PRODUCT IMPROVEMENT

NexSTAR[★]

Installation Instructions *Mini*

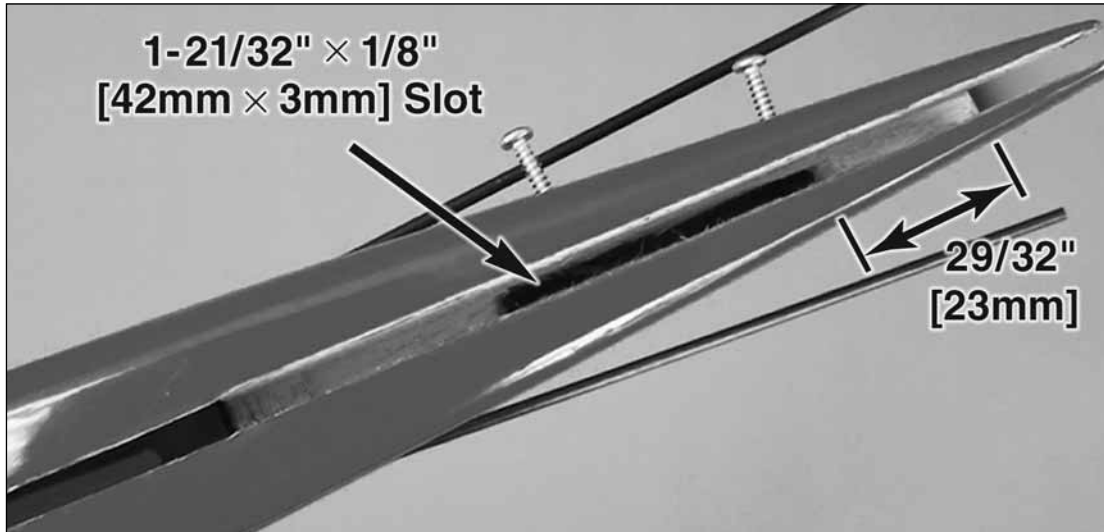
Before installing the tail surfaces, it may be necessary to cut a 1-21/32" × 1/8" [42mm × 3mm] slot at a distance 29/32" [23mm] from the rear of the fuselage, to accept the longer tab on the vertical stabilizer.
